Alabama Broadband Accessibility Fund
2020 Round One Grant Application for

**EBENEZER ROAD COMMUNITY
BROADBAND PROJECT**

SECOND PROJECT AMMENDMENT

Hayneville Fiber Transport D/B/A
Camellia Communications
P.O. Box 129

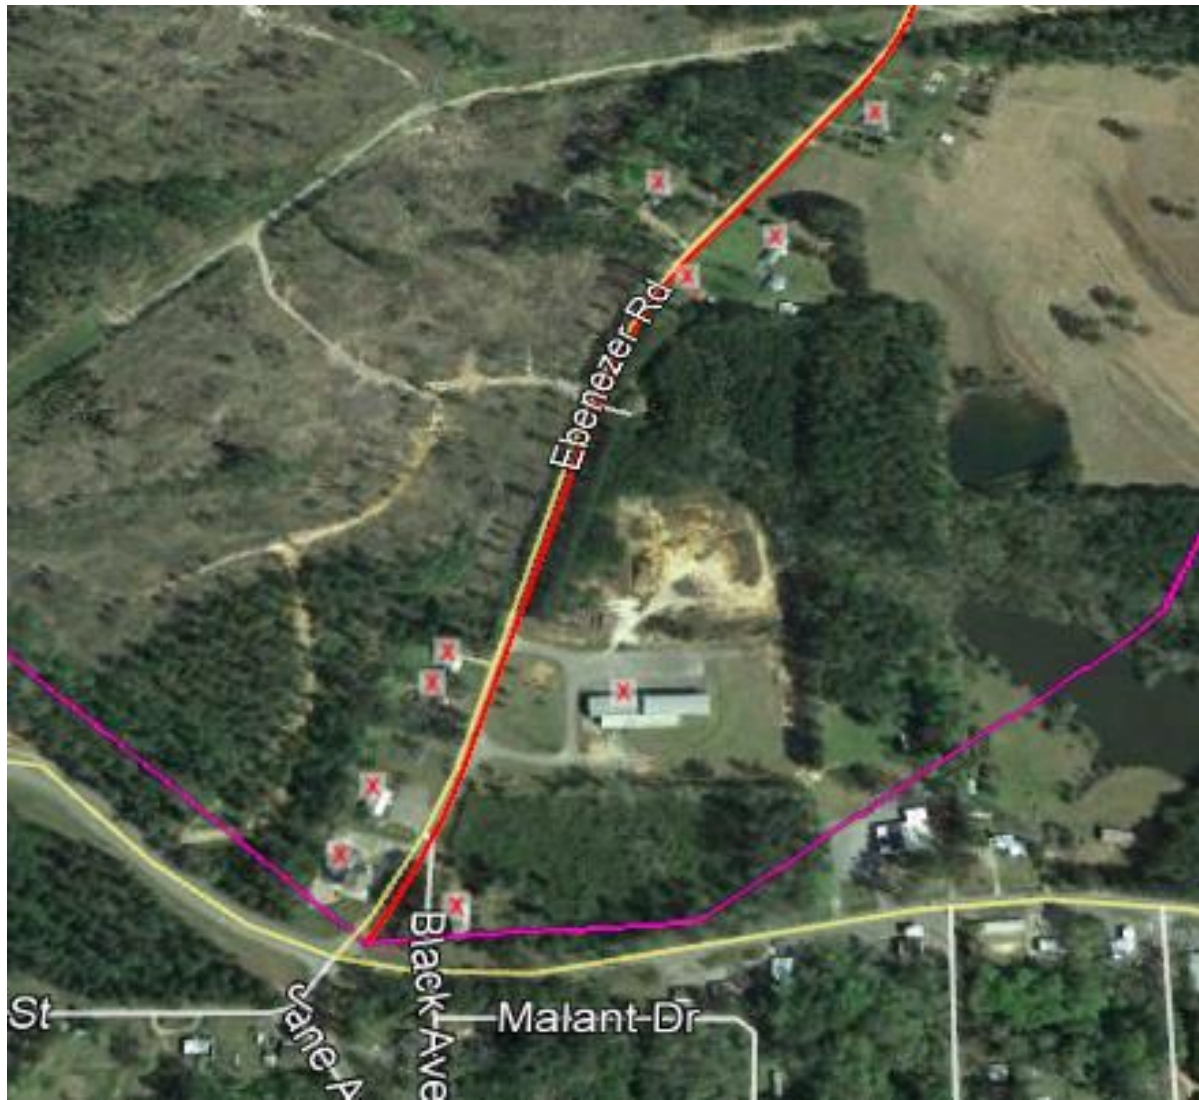
This map provided by ADECA shows that first amended service area overlaps area in gray that is covered by 25/3.

Remove 10 Subscribers and .6 miles of fiber

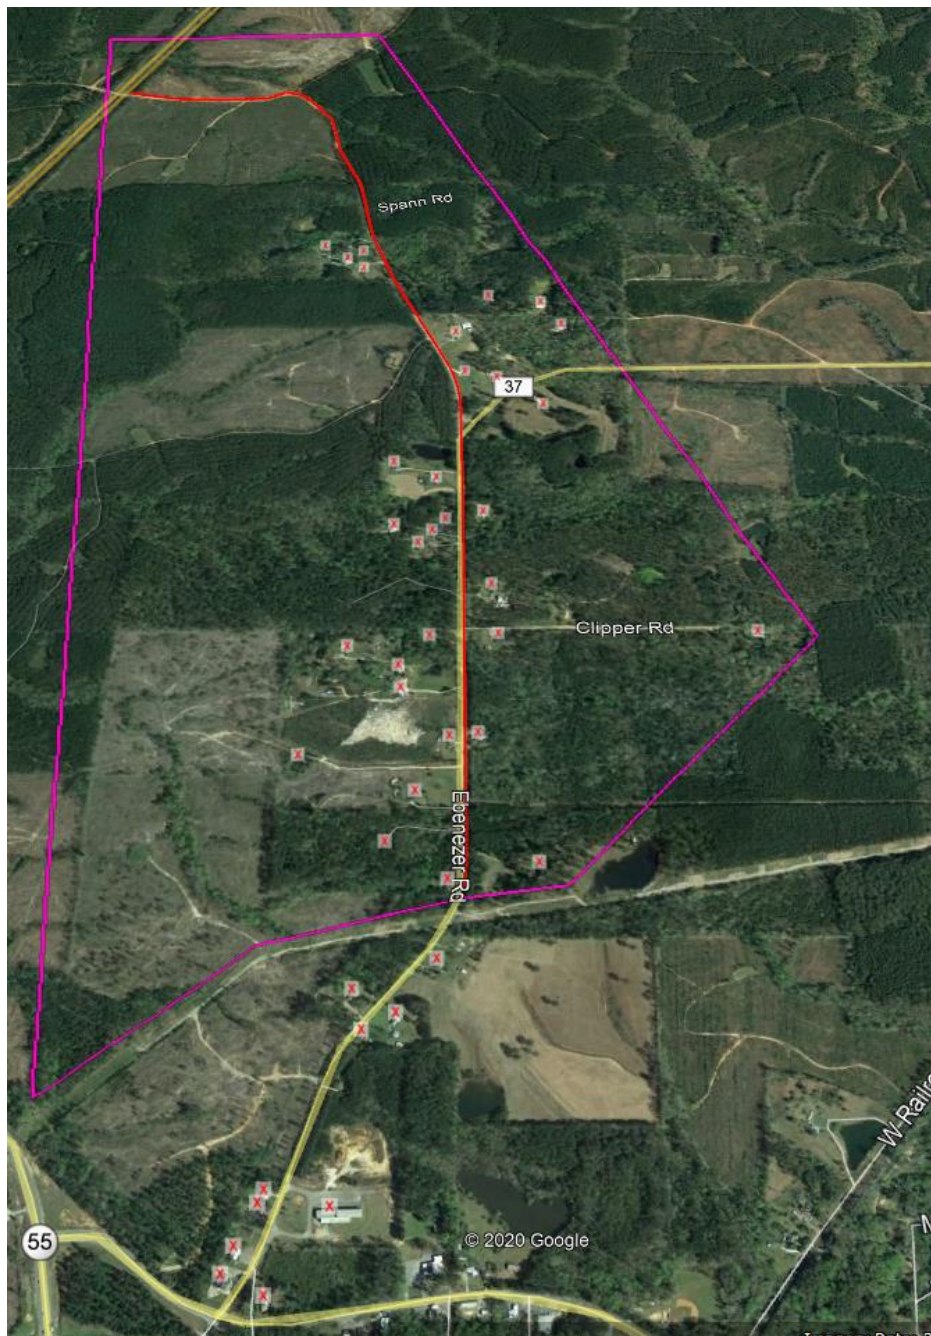
This map indicates by red "X" the 10 locations and last leg of fiber run we would like to exclude from Ebenezer Road grant application.
